Product Change Notice (PCN)

PCN Number: **PCN-0451077R-01**

Product(s) Affected: PJ-035-SMT-TR

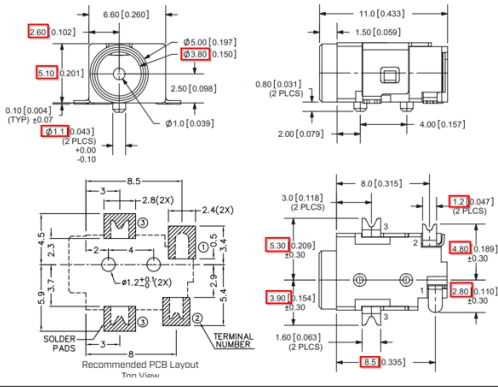
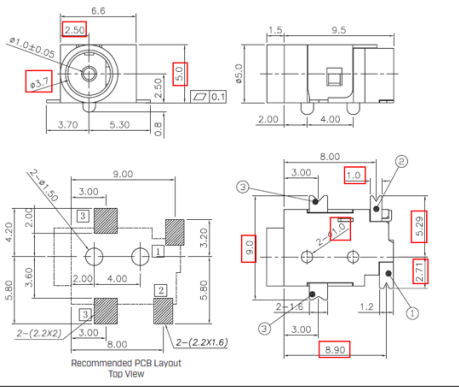
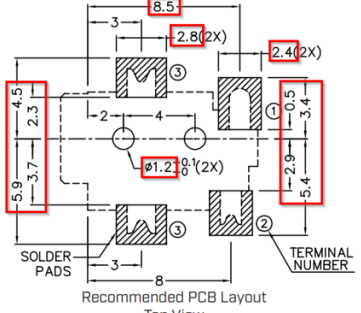
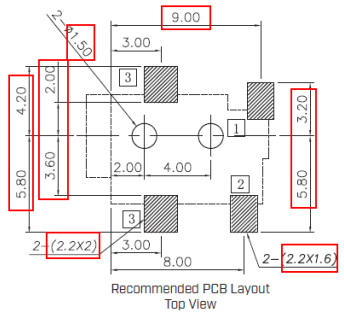
Reason(s) for Change: *Manufacturing process improvements*

Description of Change: *Mechanical, material, soldering, and packaging changes as shown below:*

<table border="1"> <thead> <tr> <th></th> <th>MATERIAL</th> <th>PLATING</th> </tr> </thead> <tbody> <tr> <td>center pin</td> <td>brass</td> <td>silver</td> </tr> <tr> <td>terminal 1</td> <td>brass</td> <td>silver</td> </tr> <tr> <td>terminal 2</td> <td>copper alloy</td> <td>silver</td> </tr> <tr> <td>terminal 3</td> <td>copper alloy</td> <td>silver</td> </tr> <tr> <td>plastic</td> <td>PA6T or equivalent</td> <td></td> </tr> </tbody> </table>		MATERIAL	PLATING	center pin	brass	silver	terminal 1	brass	silver	terminal 2	copper alloy	silver	terminal 3	copper alloy	silver	plastic	PA6T or equivalent		<table border="1"> <thead> <tr> <th>DESCRIPTION</th> <th>MATERIAL</th> <th>PLATING/COLOR</th> </tr> </thead> <tbody> <tr> <td>center pin</td> <td>copper alloy</td> <td>silver over nickel</td> </tr> <tr> <td>terminal 1</td> <td>copper alloy t=0.20</td> <td>silver over nickel</td> </tr> <tr> <td>terminal 2</td> <td>copper alloy t=0.25</td> <td>silver over nickel</td> </tr> <tr> <td>terminal 3</td> <td>copper alloy t=0.25</td> <td>silver over nickel</td> </tr> <tr> <td>housing</td> <td>PPA [UL94V-0]</td> <td>black</td> </tr> </tbody> </table>	DESCRIPTION	MATERIAL	PLATING/COLOR	center pin	copper alloy	silver over nickel	terminal 1	copper alloy t=0.20	silver over nickel	terminal 2	copper alloy t=0.25	silver over nickel	terminal 3	copper alloy t=0.25	silver over nickel	housing	PPA [UL94V-0]	black

MATERIAL	PLATING																																									
center pin	brass	silver																																									
terminal 1	brass	silver																																									
terminal 2	copper alloy	silver																																									
terminal 3	copper alloy	silver																																									
plastic	PA6T or equivalent																																										
DESCRIPTION	MATERIAL	PLATING/COLOR																																									
center pin	copper alloy	silver over nickel																																									
terminal 1	copper alloy t=0.20	silver over nickel																																									
terminal 2	copper alloy t=0.25	silver over nickel																																									
terminal 3	copper alloy t=0.25	silver over nickel																																									
housing	PPA [UL94V-0]	black																																									
<p>MATING PLUG Jack Insertion Depth: 7.3mm</p>	<p>MATING PLUG Jack Insertion Depth: 7.6mm</p>

<p>SOLDERABILITY</p> <table border="1"> <thead> <tr> <th>parameter</th> <th>conditions/description</th> <th>min</th> <th>typ</th> <th>max</th> <th>units</th> </tr> </thead> <tbody> <tr> <td>reel storage</td> <td>at relative humidity <math>\leq 80\%</math></td> <td></td> <td>40</td> <td></td> <td>$^{\circ}\text{C}$</td> </tr> <tr> <td>reflow soldering¹</td> <td>see reflow profile</td> <td>255</td> <td>260</td> <td>265</td> <td>$^{\circ}\text{C}$</td> </tr> <tr> <td>drying conditions²</td> <td>parts in reel bake at $40^{\circ}\text{C} \pm 5^{\circ}\text{C}$ for 72 hours parts removed from reel bake at $40^{\circ}\text{C} \pm 5^{\circ}\text{C}$ for 10 hours</td> <td></td> <td></td> <td></td> <td></td> </tr> </tbody> </table> <p>Note: 1. Must reflow solder within 12 hours from opening vacuum packaging at temperature $\leq 5^{\circ}\text{C}$ & relative humidity $\leq 80\%$. 2. when exceeding floor life by >72 hours.</p>	parameter	conditions/description	min	typ	max	units	reel storage	at relative humidity $\leq 80\%$		40		$^{\circ}\text{C}$	reflow soldering ¹	see reflow profile	255	260	265	$^{\circ}\text{C}$	drying conditions ²	parts in reel bake at $40^{\circ}\text{C} \pm 5^{\circ}\text{C}$ for 72 hours parts removed from reel bake at $40^{\circ}\text{C} \pm 5^{\circ}\text{C}$ for 10 hours					<p>SOLDERABILITY</p> <table border="1"> <thead> <tr> <th>parameter</th> <th>conditions/description</th> <th>min</th> <th>typ</th> <th>max</th> <th>units</th> </tr> </thead> <tbody> <tr> <td>reel storage</td> <td>$5-25^{\circ}\text{C}$, 20-75% humidity</td> <td></td> <td></td> <td></td> <td></td> </tr> <tr> <td>reflow soldering</td> <td>see reflow profile</td> <td>255</td> <td>260</td> <td></td> <td>$^{\circ}\text{C}$</td> </tr> </tbody> </table> <p>Note: 1. CU Devices recommends usage of the product within 24 hours after TBR is opened. After 24 hours, CU Devices recommends drying the parts prior to use.</p>	parameter	conditions/description	min	typ	max	units	reel storage	$5-25^{\circ}\text{C}$, 20-75% humidity					reflow soldering	see reflow profile	255	260		$^{\circ}\text{C}$

parameter	conditions/description	min	typ	max	units																																						
reel storage	at relative humidity $\leq 80\%$		40		$^{\circ}\text{C}$																																						
reflow soldering ¹	see reflow profile	255	260	265	$^{\circ}\text{C}$																																						
drying conditions ²	parts in reel bake at $40^{\circ}\text{C} \pm 5^{\circ}\text{C}$ for 72 hours parts removed from reel bake at $40^{\circ}\text{C} \pm 5^{\circ}\text{C}$ for 10 hours																																										
parameter	conditions/description	min	typ	max	units																																						
reel storage	$5-25^{\circ}\text{C}$, 20-75% humidity																																										
reflow soldering	see reflow profile	255	260		$^{\circ}\text{C}$																																						
<p>units: mm Reel Size: Ø360 mm Reel QTY: 850 pcs per reel</p> <p>GATHER MATERIAL DIRECTION INPUT MATERIAL DIRECTION</p> <p>COVER TAPE CARRIER TAPE</p> <p>A: Empty 160 mm min. B: Empty 100 mm min. C: Cover 400 mm min.</p> <p>PLASTIC REEL COVER TAPE CARRIER TAPE REEL</p>	<p>units: mm Reel Size: Ø330 mm Reel QTY: 1000 pcs per reel</p> <p>REEL DIRECTION</p>
